Access Compliance Report Public Rights-of-Way (Curb Ramps)

Intersection ID: 16396 Main Street: BEAL_ST Cross Street: N_WENDOVER_RD Location: W

ADA ID: 83D611C68E72 Ramp Type: PerpDiag Initial Pass/Fail: Fail Overall Compliance: No Severity Score: 13.75

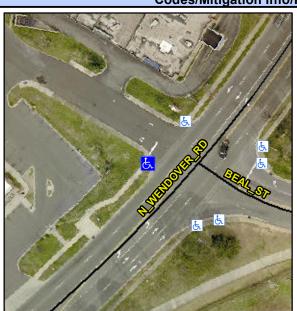
Remove & Replace Curb Ramp With Two New Directional Ramps or Equivalent.

R304.2.2, R304.5.3
